**Subject:** Response to Request for Additional Information Regarding 10 CFR 50.55a  
Request RI-35, Revision 1  
Cooper Nuclear Station, Docket No. 50-298, DPR-46

**Response to Request for Additional Information (RAI)  
 Related to Relief Request RI-35, Revision 1**

**Cooper Nuclear Station (CNS), Docket No. 50-298, DPR-46**

**Figure 1**

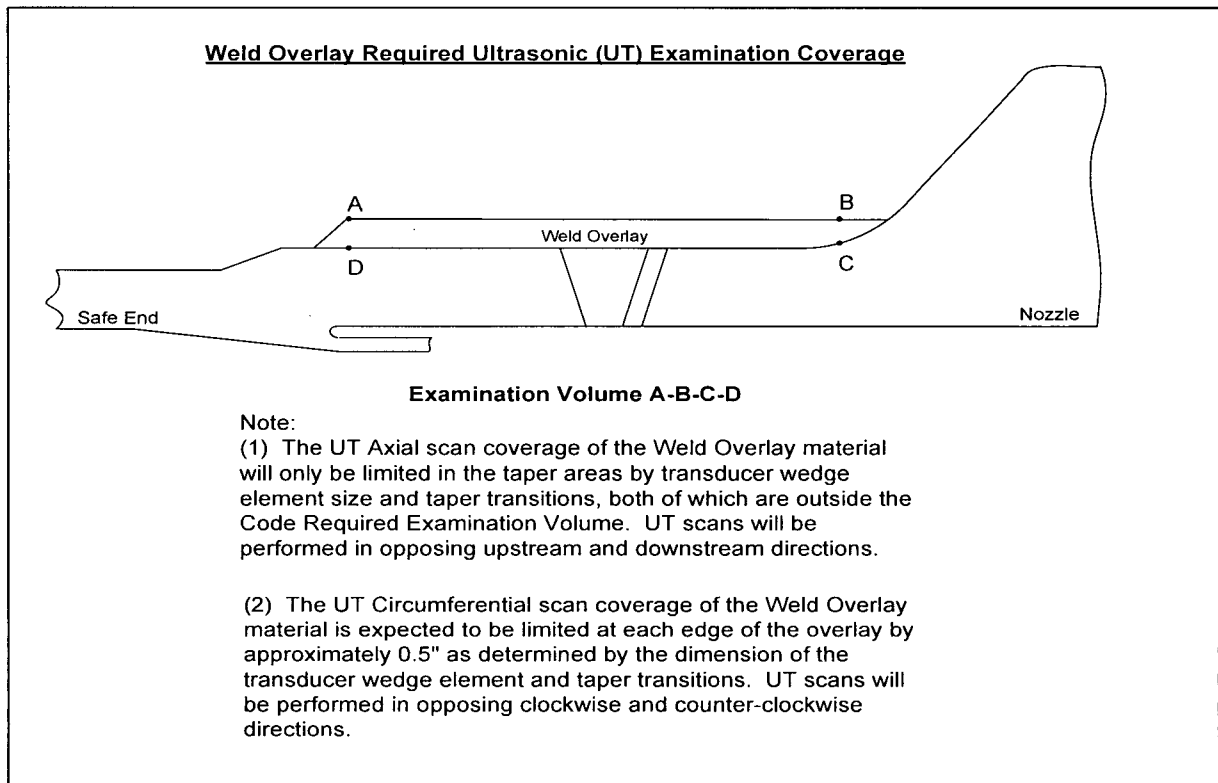
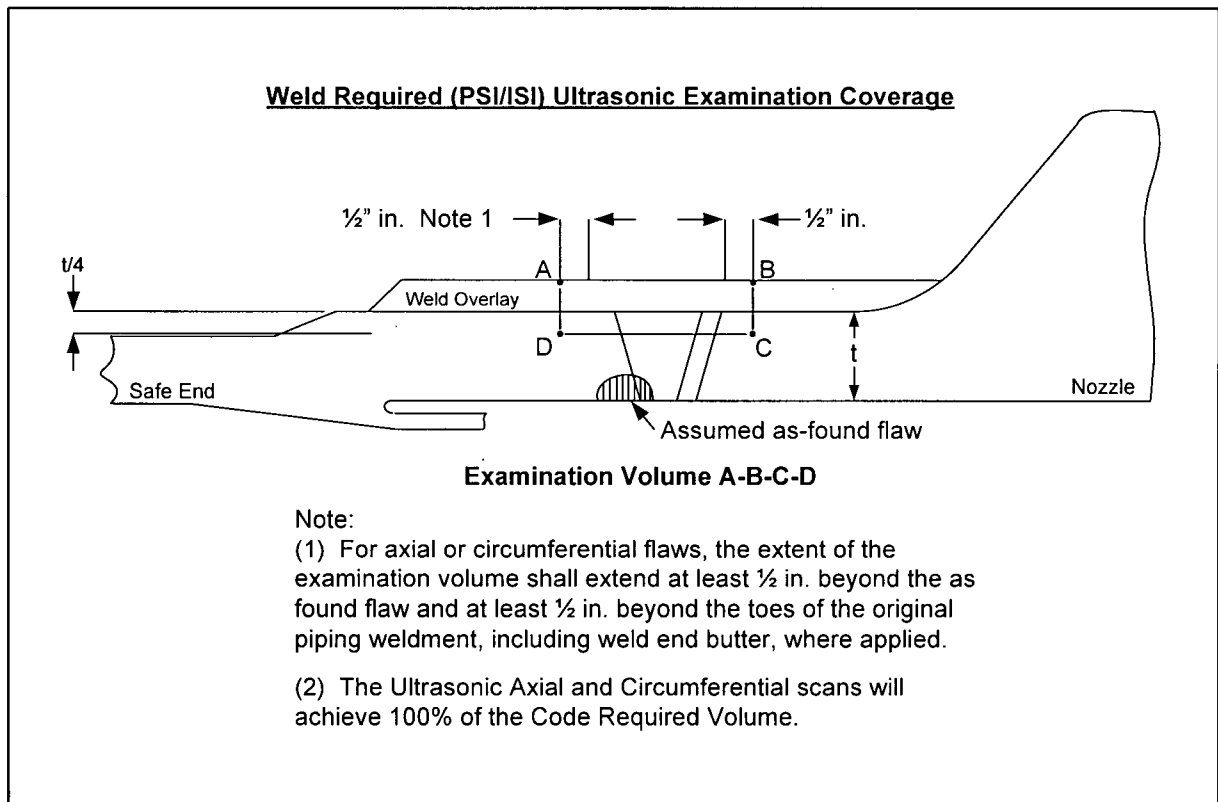
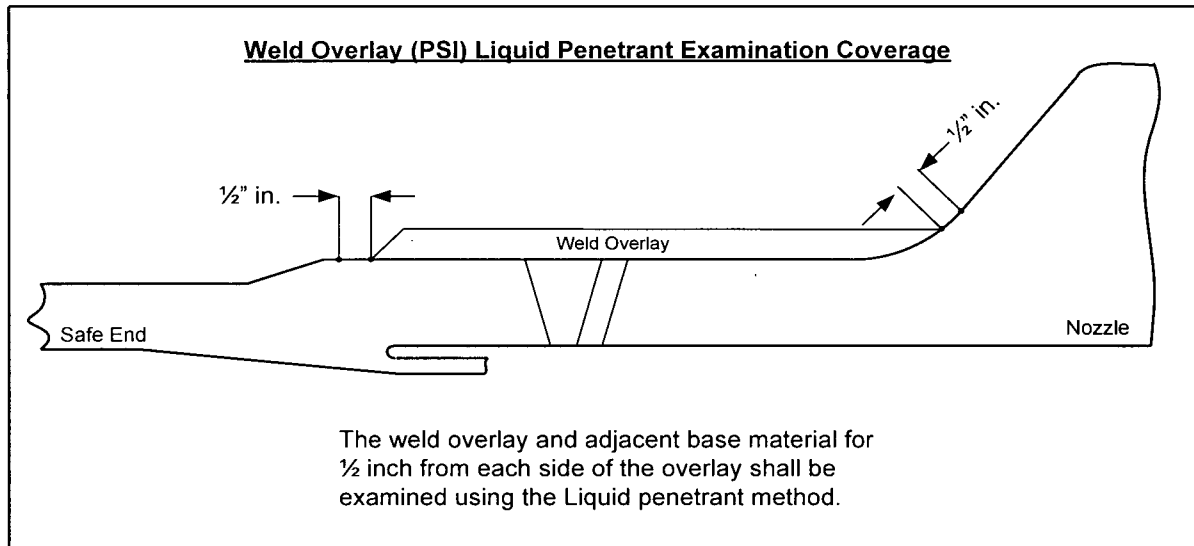
*The relief request states that full ultrasonic examination of the final weld surface and band area (1.5T width) will not be performed. Provide a sketch similar to Figure 1 in RI-35 to describe how much of the final weld surface and band area will be post-weld examined using the ultrasonic method and how much of the final weld surface and band area will be examined by the liquid penetrant method. Provide a detailed explanation for the basis that the liquid penetrant method can be substituted for the ultrasonic method in areas where the ultrasonic method will not be used.*

Full ultrasonic examination of the 1.5T band will not be possible due to geometric interferences. The ultrasonic examination may not extend up to the very edge of the overlay. The weld overlay will extend into the blend radius of the nozzle for structural reinforcement. This extension into the blend radius eliminates a stress riser on the nozzle and may provide additional surface area for ultrasonic examination of the defect area in the original weld. Figures 1 and 2 identify the extent of coverage expected for scans in the circumferential and axial directions. The full WOL surface will be scanned.

Because this is a surface application of a temperbead welding process (specifically performed to minimize heat input into the ferritic steel nozzle), there is minimal impact to the volume of the ferritic shell nozzle material in the area surrounding the weld overlay. Also, no additional useful information can be gained by a volumetric examination of the area beyond the physical boundaries of the weld overlay. The weld and heat affected zone beneath the weld overlay will be volumetrically examined after welding to ensure that sound weld metal has been deposited and that the process did not introduce flaws into the base material. Surface examinations of the weld overlay surface will be performed (See Figure 3 for the examination area). This is sufficient to verify that defects were not introduced in either the ferritic steel nozzle or stainless steel safe-end due to welding.

Later editions of Section XI as well as Code Case N-638-2 have deleted the requirement for the 1.5T examination band for both ultrasonic examination and surface examination. This is consistent with the less restrictive requirements for ultrasonic examination of the ferritic nozzle because hydrogen cracking away from the temper bead weld is not considered a concern. The nondestructive examination (NDE) requirements in these documents apply to any type of welding where a temperbead technique is to be employed (which includes weld repairs of excavated flaws) and is not specifically written for weld overlay. For the weld overlay type of repair, any ferritic steel base material cracking would occur in the HAZ directly below or adjacent to the weld overlay and not in the 1.5T examination band of ferritic material beyond the edges of the weld overlay. If this type of cracking occurs it will be detected by the NDE of the weld overlay and adjacent ferritic steel surfaces as described in the relief request and non-mandatory Appendix Q.
